ADDENDUM NO. 3

REYNOLDSBURG CITY SCHOOLS
L.F.O. ATHLETIC & ECO LAB PROJECTS

Date: **March 31, 2011**

Addendum No. 3 to the Drawings and Project Manual, dated **March 17, 2011**, for **L.F.O. ATHLETIC & ECO LAB PROJECTS**, Reynoldsburg City Schools, 7244 East Main Street, Reynoldsburg, Ohio 43068; as prepared by Moody Nolan, Inc., 300 Spruce St. Suite 300, Columbus, OH 43215.

7 1 1/2" QUICK COUPLER VALVE & BOX
NO SCALE

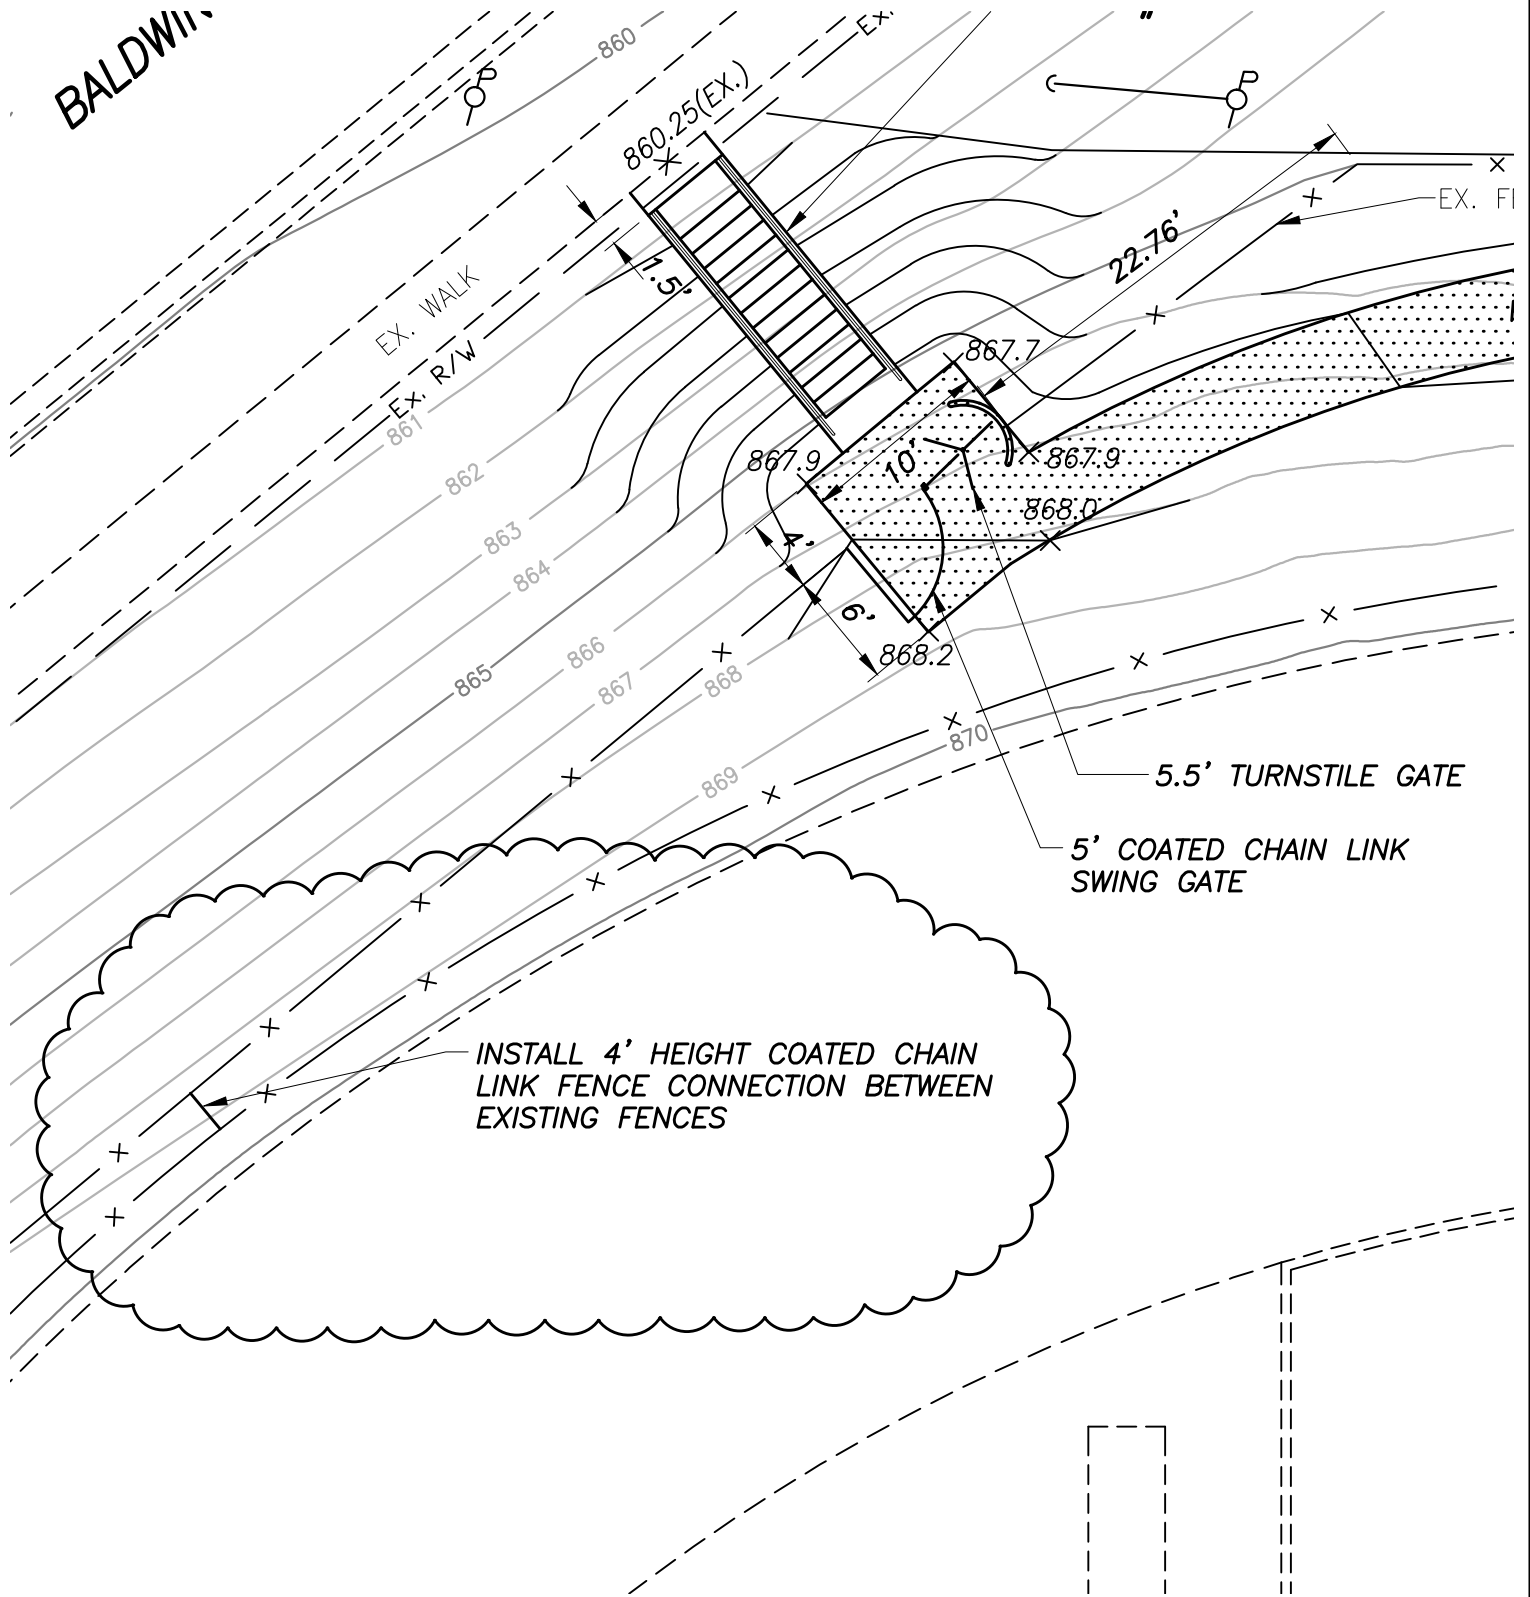
- Item 2-16 Drawing Cs4.1
a. **ADD** Pipe Gate Detail, see sketch C-SK14.
b. **REVISE** Detail 7 Quick Coupler Detail, see sketch C-SK16.

1. SEE PLANS AND SPECIFICATIONS FOR ADDITIONAL INSTALLATION NOTES.
2. CONTRACTOR TO PROVIDE KIFCO T180 WATER WHEEL w/ SIME HYDRA SPRINKLER AND ALL REQUIRED FITTING, SEE SPECIFICATIONS.

C-SK01

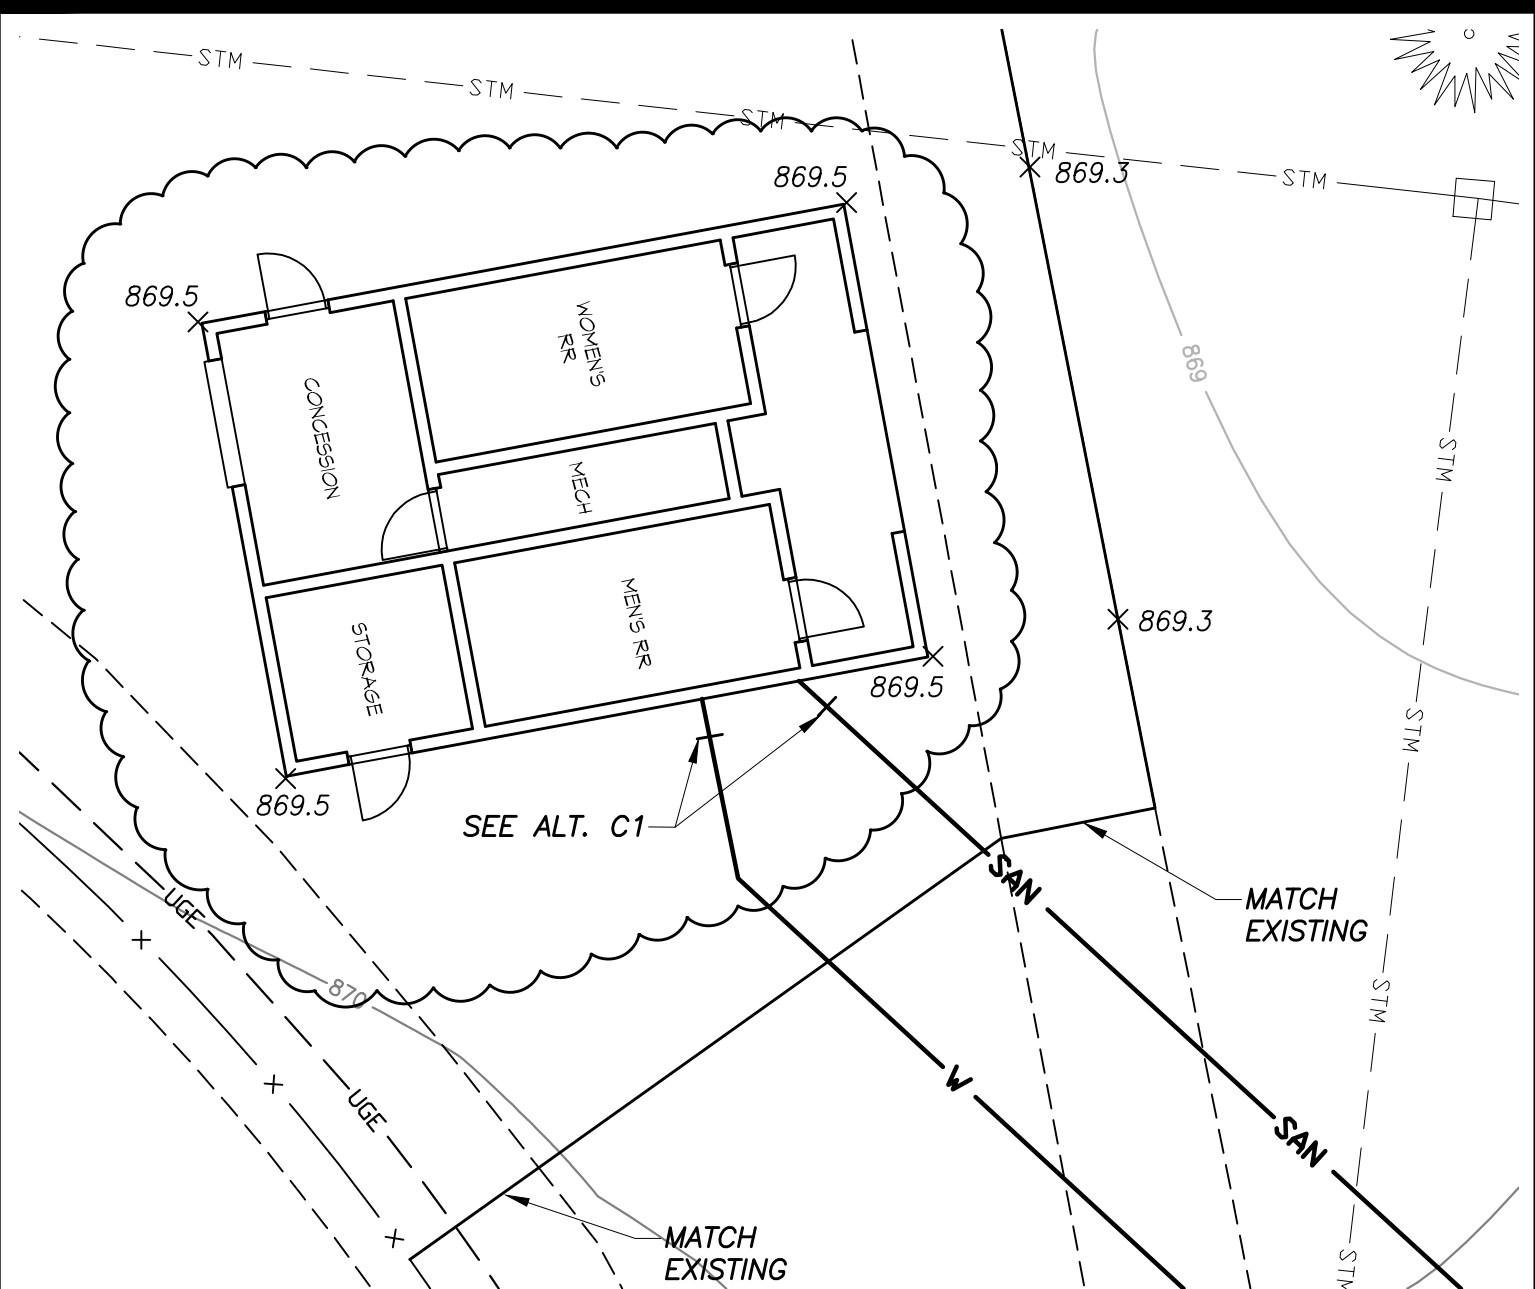
- Item 2-3 Drawing CI0.2
REVISE Coded Note 3 to: Existing Trailers to be removed by others. Coordinate removal with C.M.
- Item 2-4 Drawing CI1.3
ADD fence connection between the two existing fences, see sketch C-SK01.

INSTALL 4' HEIGHT COATED CHAIN
LINK FENCE CONNECTION BETWEEN
EXISTING FENCES

ISSUED WITH ADDENDUM 3	SHEET REVISED C11.4
SKETCH NUMBER C-SK02	
PROJ # 081TT.I	DRAWN BY MAB
DATE 3/30/11

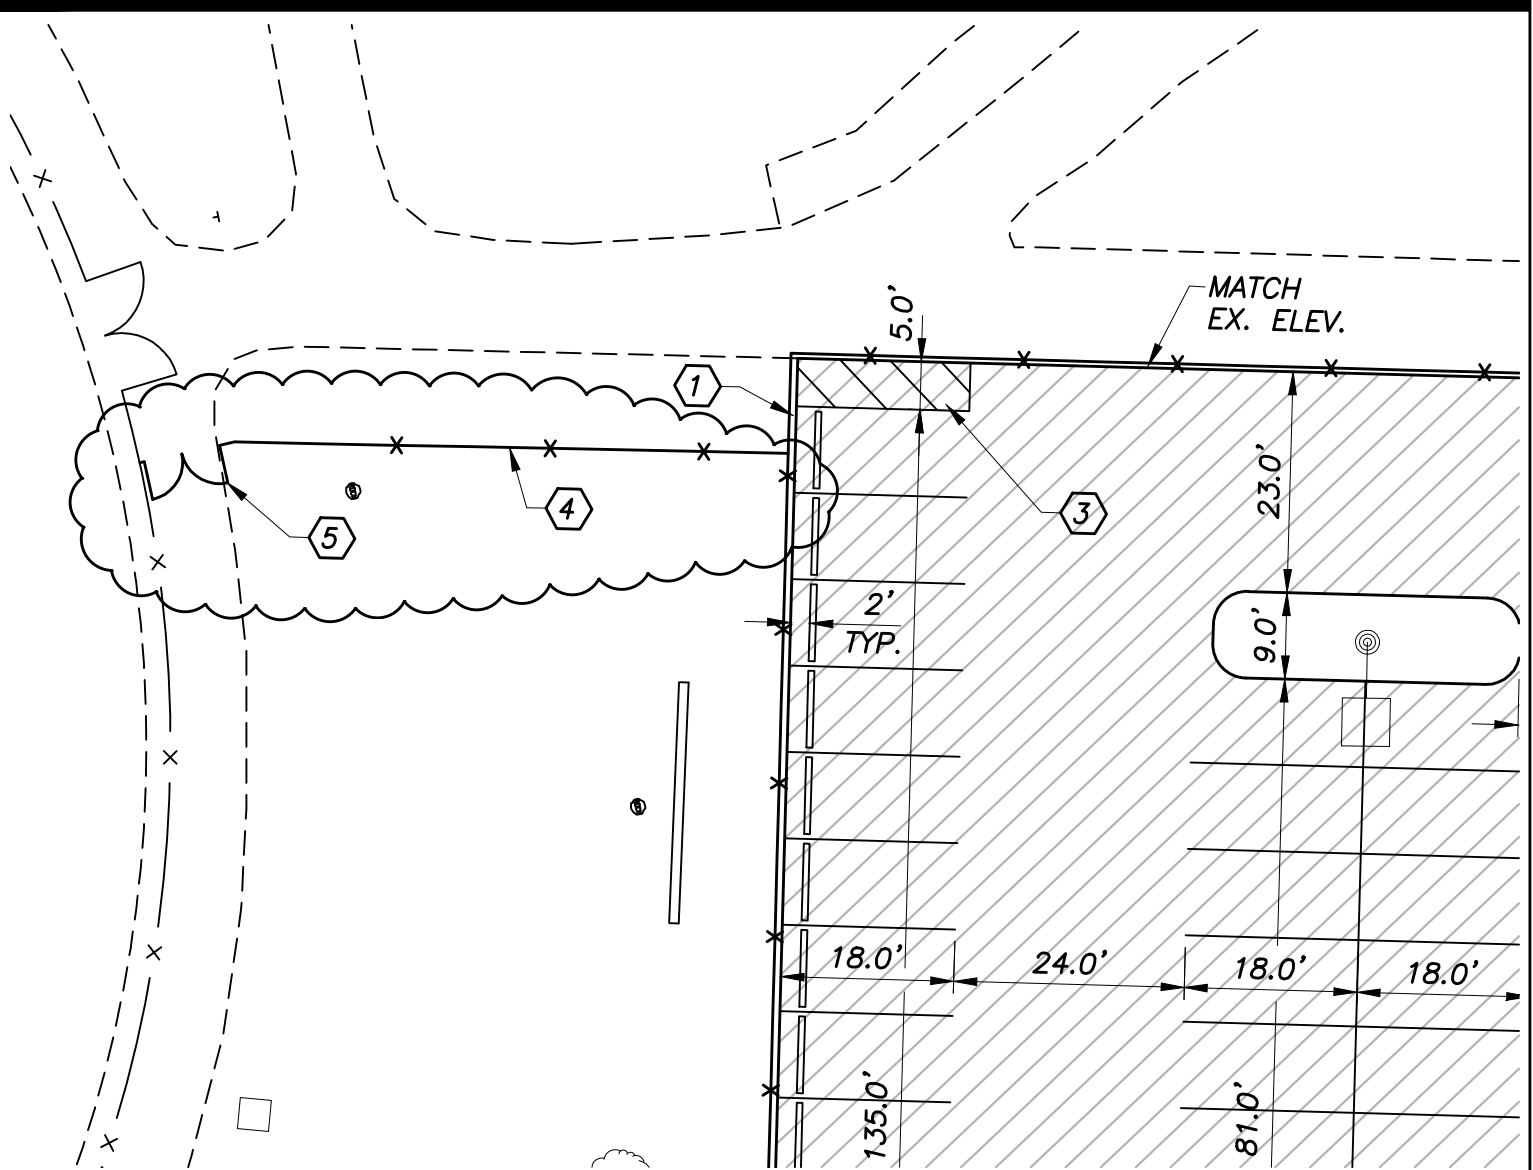
- Item 2-5 Drawing CI1.4
REVISE Alternate Bid text, see sketch C-SK02.
- Item 2-6 Drawing CI1.5
ADD fence and gates, add Coded Notes 4 & 5, revise Coded Note 2. See sketch C-SK03.

- ALTERNATE BID:**
- A1 - 26'-0"x31'-0" PRE-FABRICATED BUILDING
 - A2 - 26'-0"x34'-6" PRE-FABRICATED BUILDING
 - B1 - 26'-0"x31'-0" SIERRA III PRE-ENGINEERED BUILDING
 - B1 - 26'-0"x34'-6" SIERRA IV PRE-ENGINEERED BUILDING
 - C1 - PROVIDE LABOR AND MATERIAL FOR CONCRETE PAVING WITH AGGREGATE BASE IN UNFILLED BUILDING AREA TO MATCH ADJACENT. CAP PROPOSED WATER AND SANITARY.

ISSUED WITH ADDENDUM 3	SHEET REVISED C11.5
SKETCH NUMBER C-SK03	
PROJ# 081TT.1	DRAWN BY MAB
DATE 3/30/11

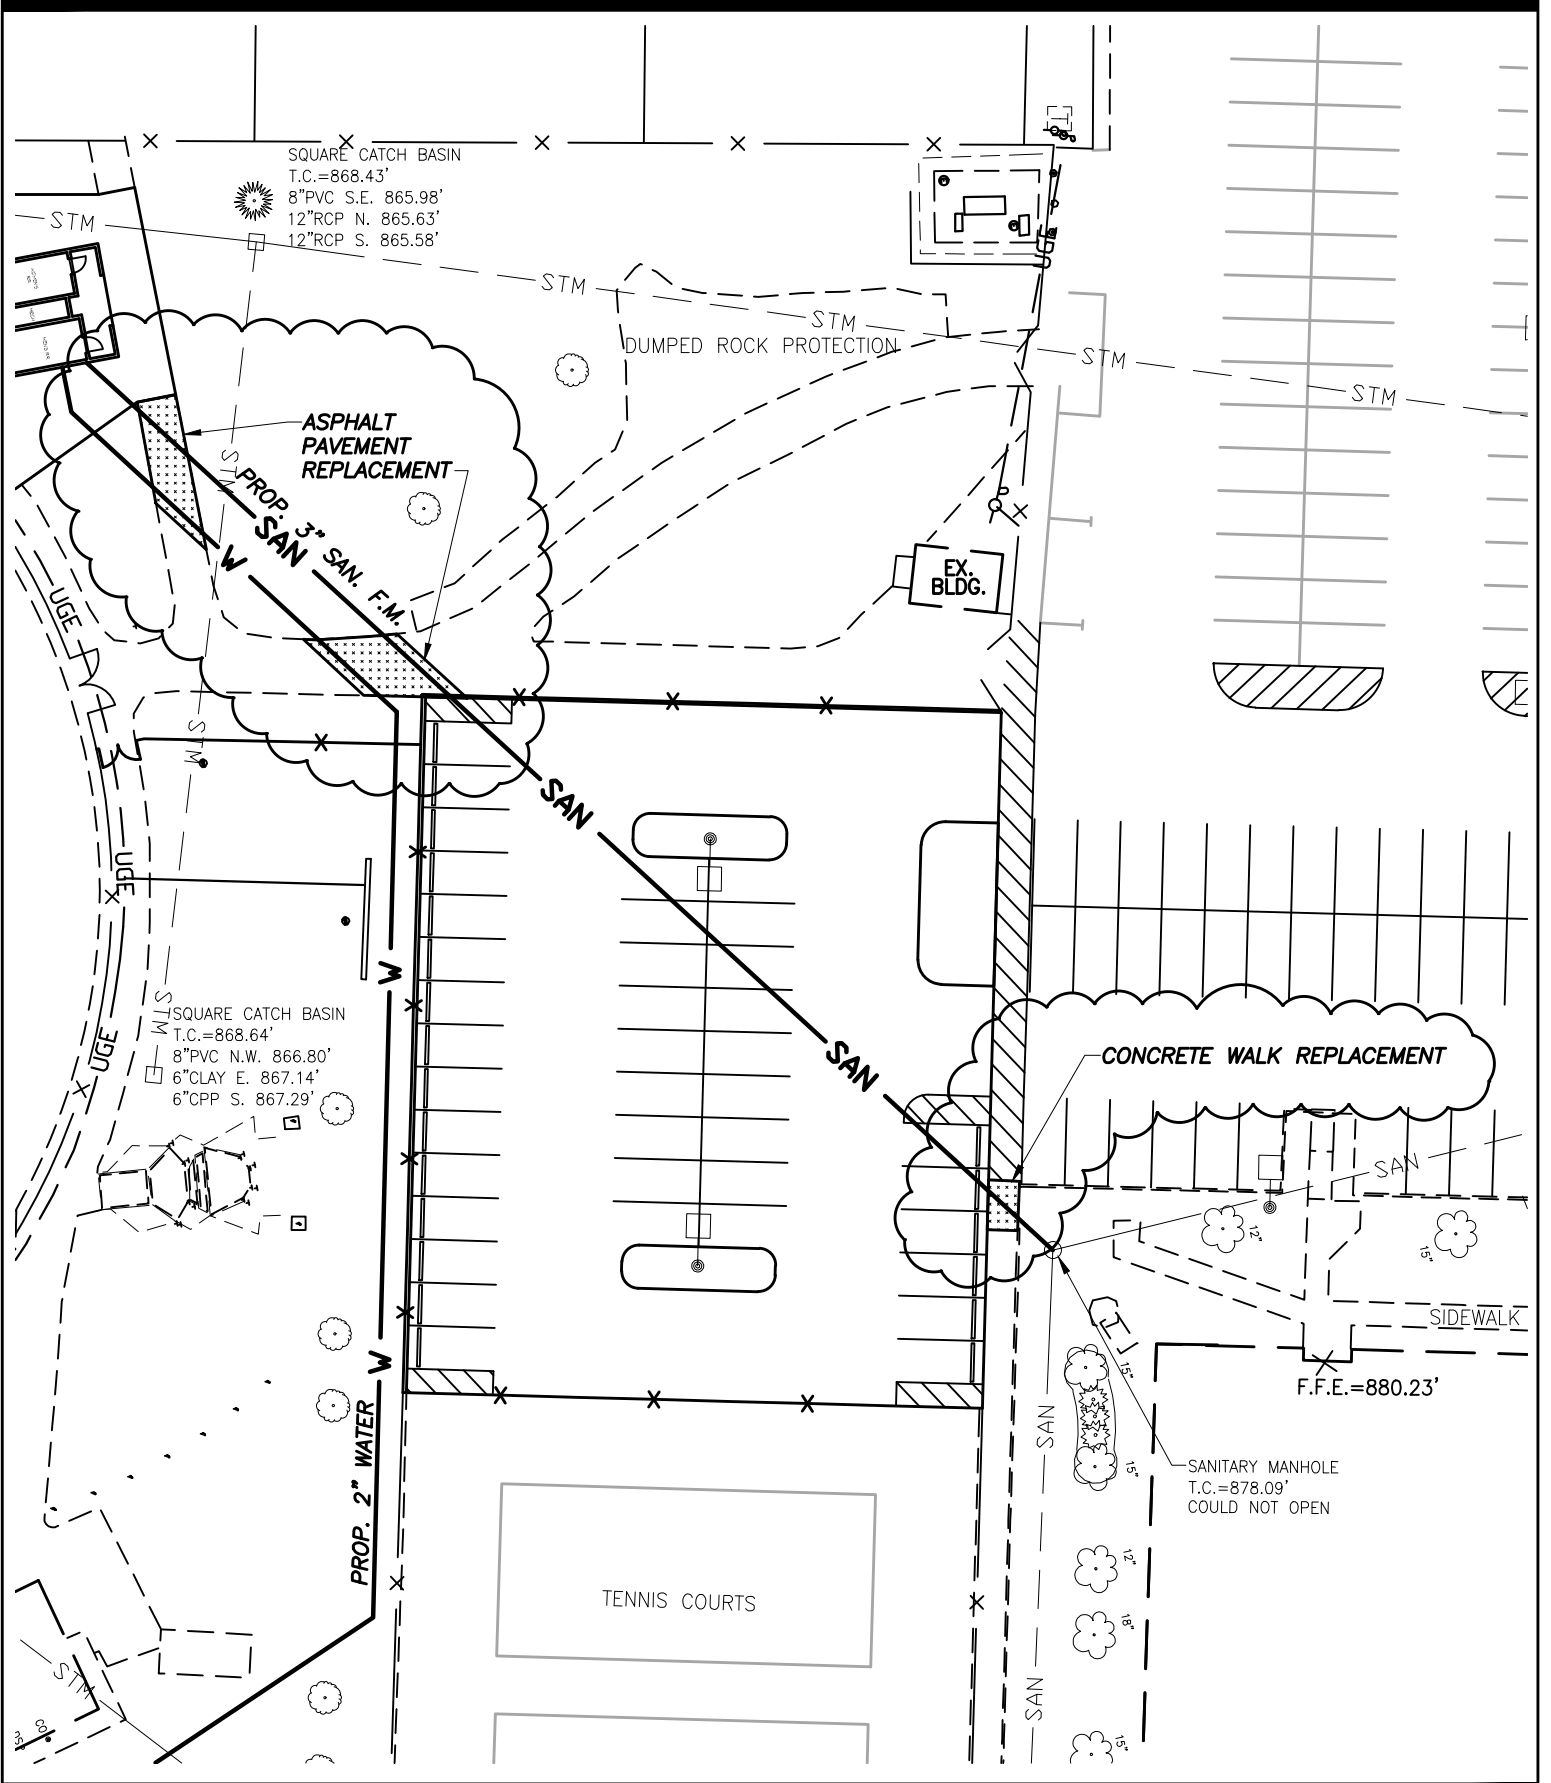
- ① 6' HEIGHT COATED CHAIN LINK FENCE
- ② 10' HEIGHT GREEN COATED CHAIN LINK FENCE
- ③ TRANSVERSE LINE, 4" WHITE, 3' SPACING FOR CROSSWALKS AND ISLANDS
- ④ 4' HEIGHT COATED CHAIN LINK FENCE
- ⑤ 4' COATED CHAIN LINK DOUBLE SWING GATE

ISSUED WITH ADDENDUM 3	SHEET REVISED CI3.1
SKETCH NUMBER C-SK04	
PROJ # 08177.1	DRAWN BY MAB
DATE 3/30/11

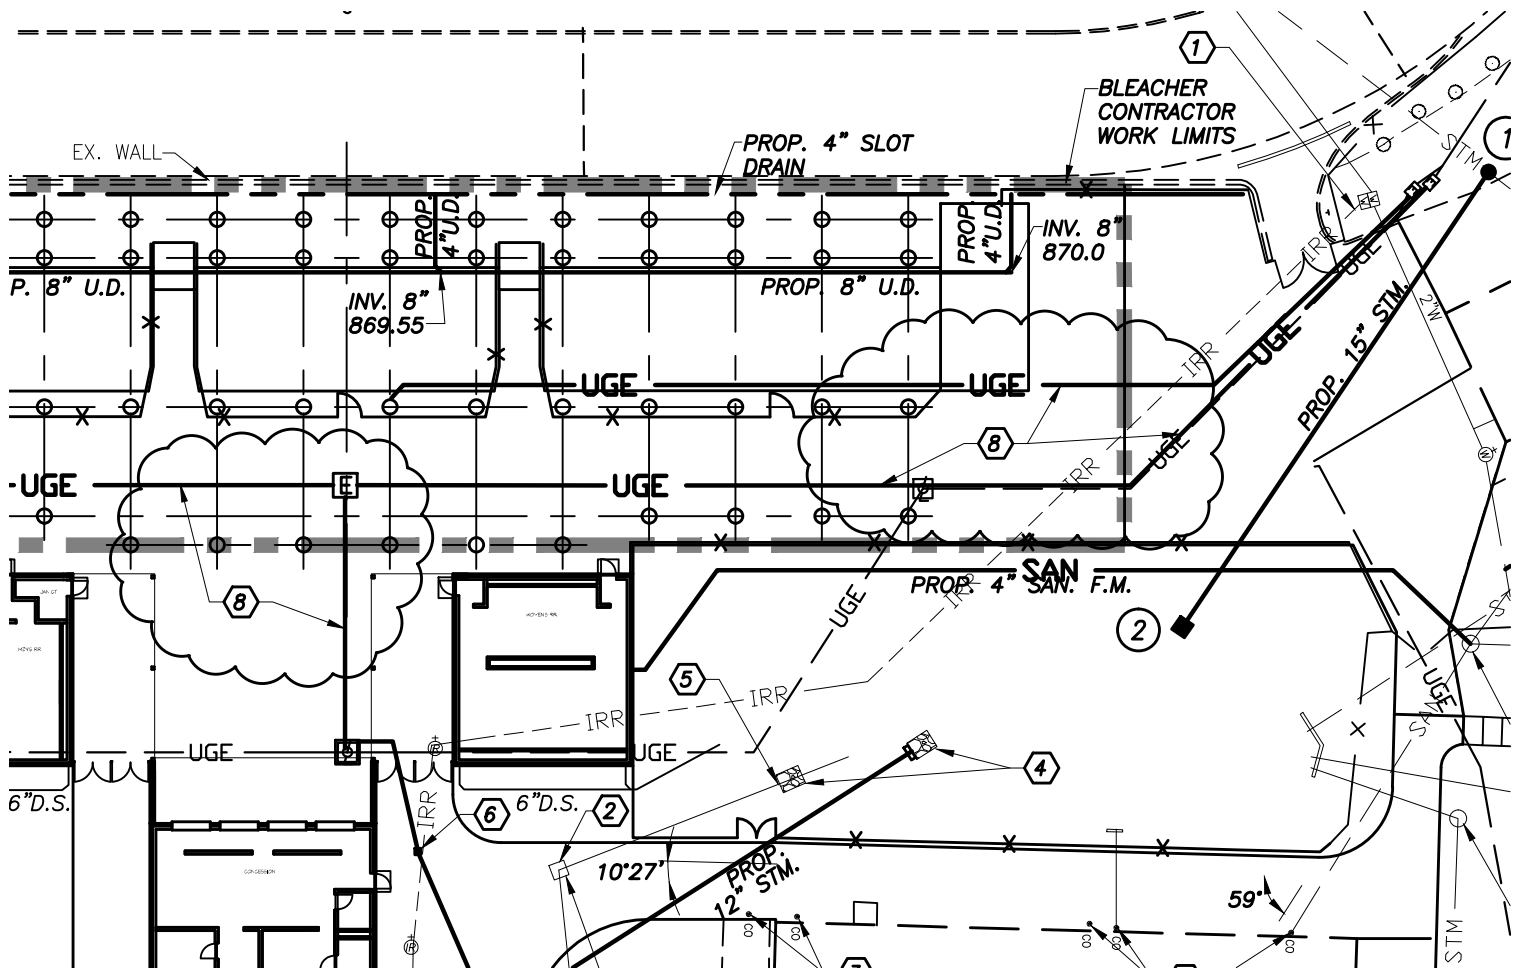
- Item 2-9 Drawing CI3.1
ADD pavement repair areas, add Coded Note 8, revise Coded Note 1. See sketches C-SK04 & C-SK05.
- Item 2-10 Drawing CI5.3
REVISE Detail 15 Release Structure, see sketch C-SK06.
